<b>INNER WEST COUNCIL</b>	
<b>PLANNING PROPOSAL REPORT</b> <b>From the Planning Operations Team – Strategic Planning</b>	
<b>Planning Proposal No.</b>	IWC_PP_2018_02
<b>Address</b>	1 - 5 Chester Street, Annandale
<b>Proposal</b>	Make amendments to the Leichhardt Local Environmental Plan 2013 to rezone the site from Light Industrial to Medium Density Residential, Increase the Floor Space Ratio and introduce a Maximum Building Height control.
<b>Main issues</b>	Prematurity in relation to the Parramatta Road Corridor Urban Transformation Strategy Implementation Plan staging; Loss of industrial land; Bulk and scale.
<b>Recommendation</b>	That the Panel provide advice to Council on the merits of the Planning Proposal.

Council received a Planning Proposal from ae design partnership on 2 February 2018 for 1 - 5 Chester Street, Annandale, requesting an amendment to the Leichhardt Local Environmental Plan (LLEP) 2013. The Proposal seeks to rezone the site from Light Industrial (IN2) to Medium Density Residential (R3), increase the floor space ratio to 2.6:1 and introduce a new height control of 17m. A site-specific development control plan is also proposed as part of the application.

Figure 12 - Extract from the proponent's design scheme with a 5 storey building facing Chester street, 6 storey building facing Johnstons Creek communal open space on the ground level and roof top level.

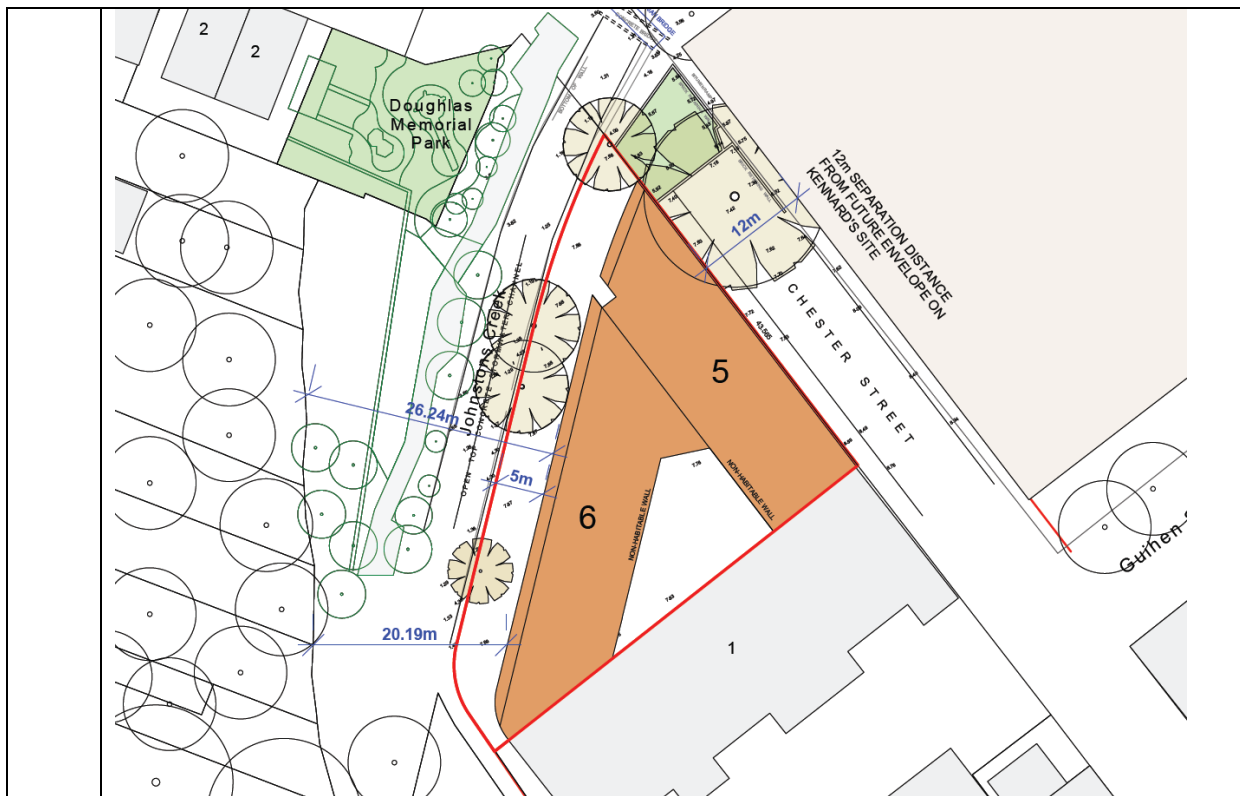
The key concerns in relation to the proposed concept design are detailed below:

- **Overshadowing:** The proposed communal open space on the ground level of the development is completely overshadowed in mid-winter between 9 am to 3pm as shown in the image below. This would adversely impact the amenity of the future residents of the development.

In order to resolve the above design issues, the proposal would have to be revised to reduce the bulk and provide adequate setbacks, articulations and transitions. The recommended density of 1.5:1 and building height of 17m in PRCUTS are appropriate development controls for the site. These would adequately resolve the above issues and achieve a built form that is consistent with the existing and desired future character of the area.

Figure 15 - Extract from proponent's Urban Design scheme indicating the relationship of the built form along Chester Street with the adjacent building at No. 8 Guihen Street. Red blurb indicating the potential street widening on the adjacent site.

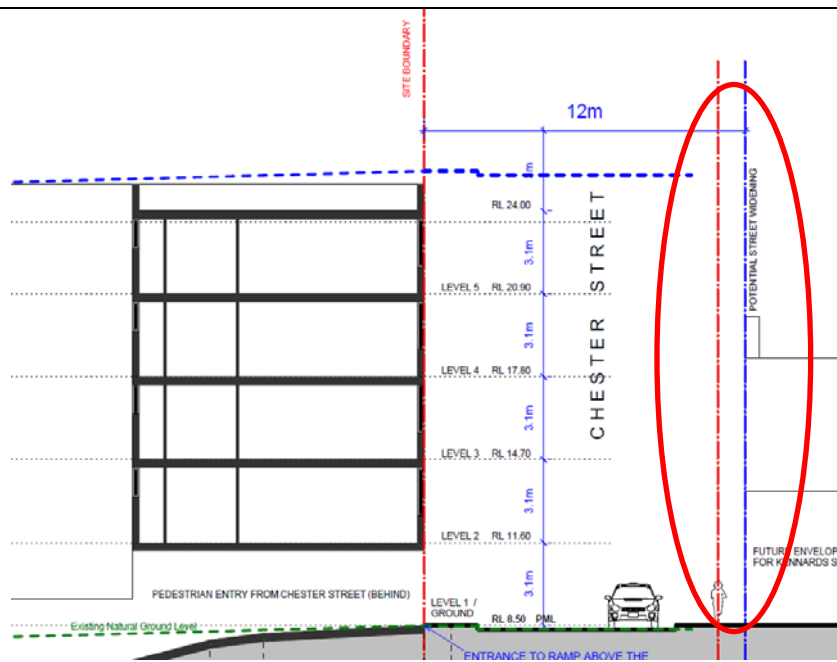
The ADG requires a separation distance of 18m between habitable rooms/balconies or 12m between habitable and non-habitable rooms for buildings between 5 to 8 storeys. In this regard, the proposal would provide an inadequate separation distance to 8 Guihen Street and restrict its development potential by assuming that this site in another ownership would accommodate any necessary widening of Chester Street. This approach is unacceptable and the proponent should work within the constraints of their own site without relying on the contribution of setbacks/ widenings from adjacent sites.

Notwithstanding this 5 storey street wall height along Chester Street is also inconsistent with the character of the surrounding area. In this regard, upper levels should be setback to reinforce the desired scale of buildings at the street frontage.

In addition, a ground level setback to Chester Street would be desirable:

Figure 16 - Indicative ground level of the proposed development.

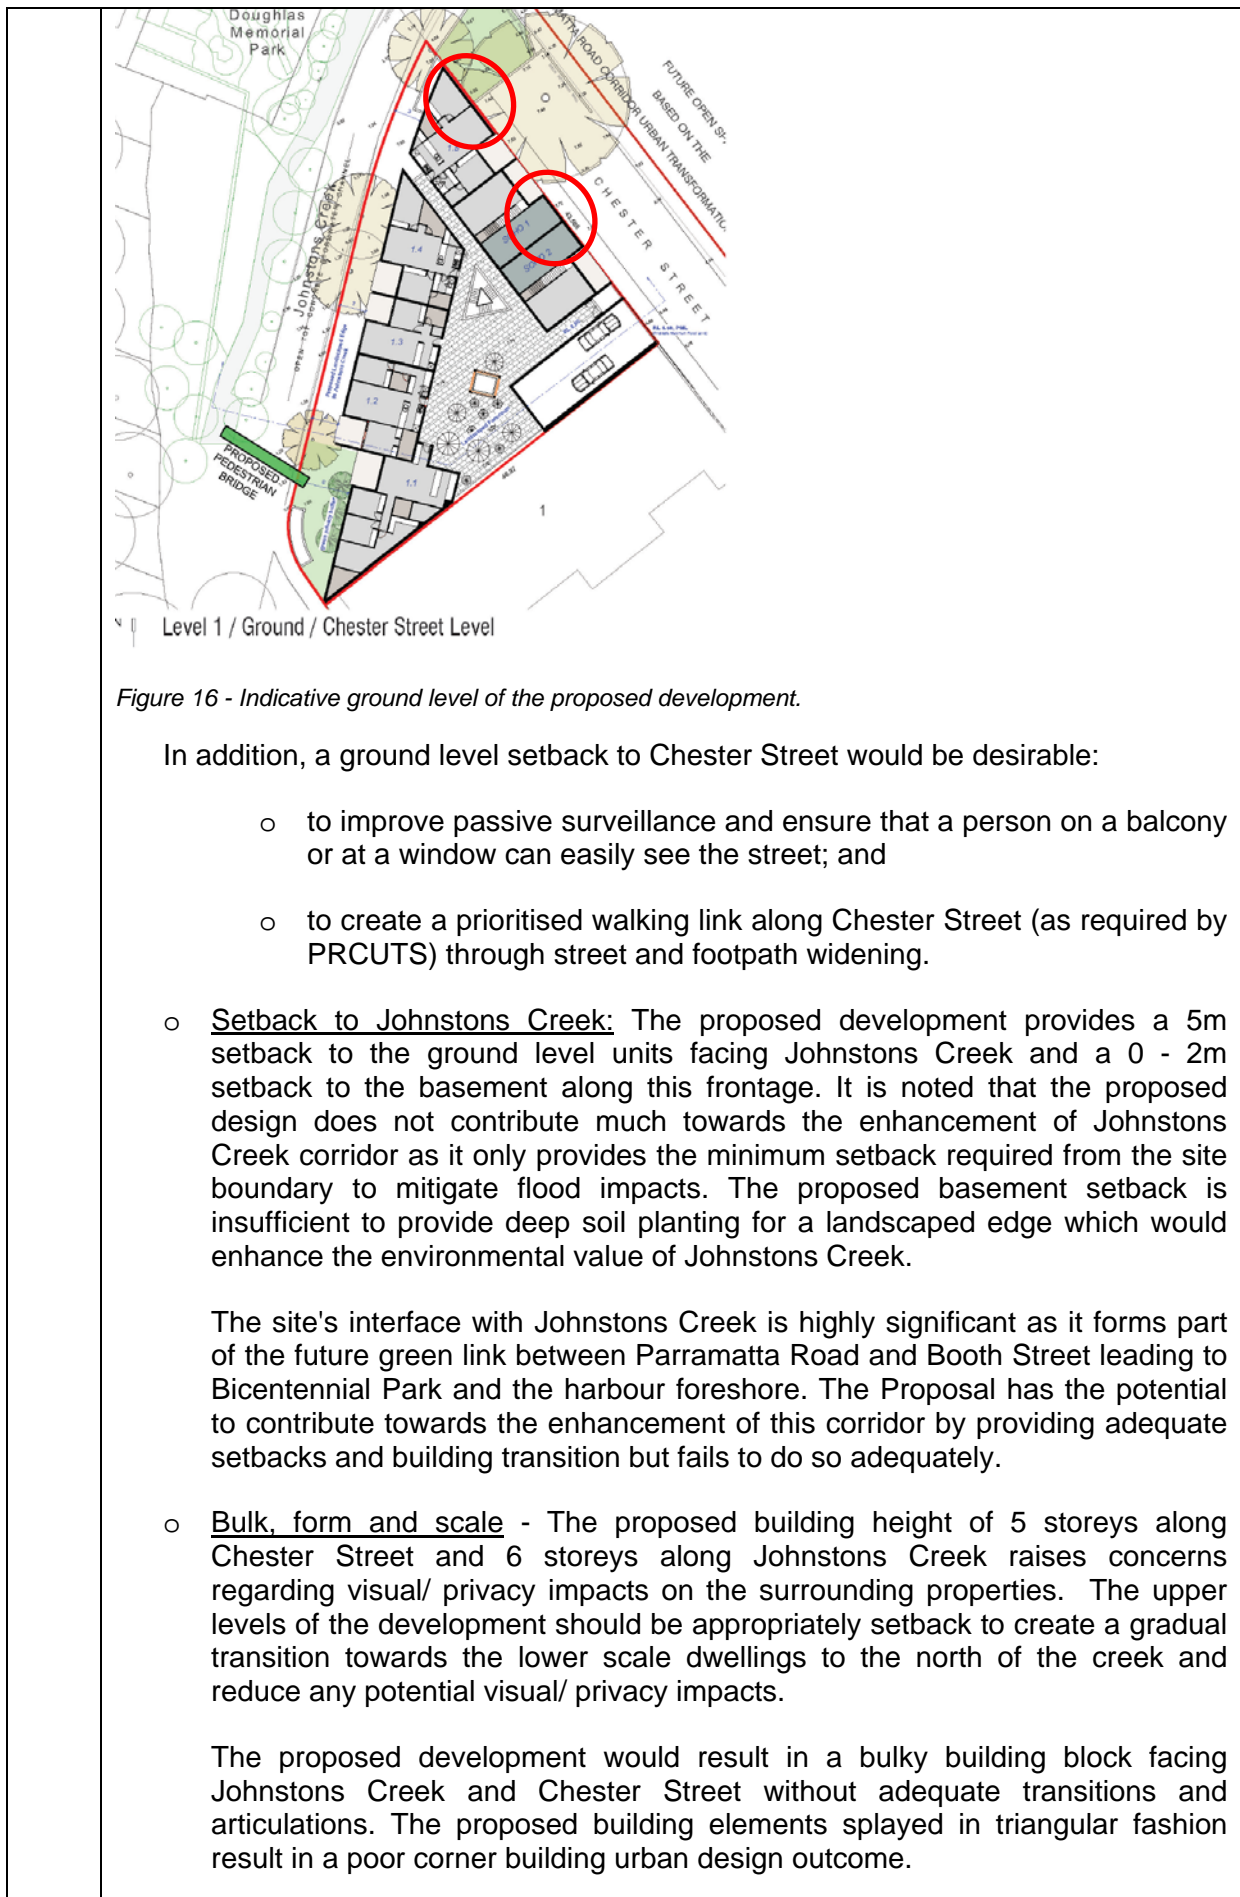
The proponent has also not demonstrated how the proposed development would maintain the visual privacy of future residents. The proposed units on the ground floor along Chester Street do not provide adequate visual/ acoustic privacy (as shown below in Figure 16).

The proposed units on the ground floor along Chester Street do not provide adequate visual/ acoustic privacy for the future residents of the development and surrounding area as discussed previously. The future residents would be significantly affected by the imminent installation of a basketball hoop and concrete pad in the pocket park by Council. The proposed dwellings on the ground floor level are therefore a concern in terms of their relationship with the use and enjoyment of the pocket park. There are similar concerns in relation to the dwellings facing Johnstons Creek which will be close to the future shared path.

If the Planning Proposal proceeds to the DA stage, the proposed development consent must be conditioned to incorporate acoustic walls and measures to protect the visual and acoustic privacy of its future residents and ensure long term recreational use of the park and shared path along Johnstons Creek is not compromised by complaints from these residents.
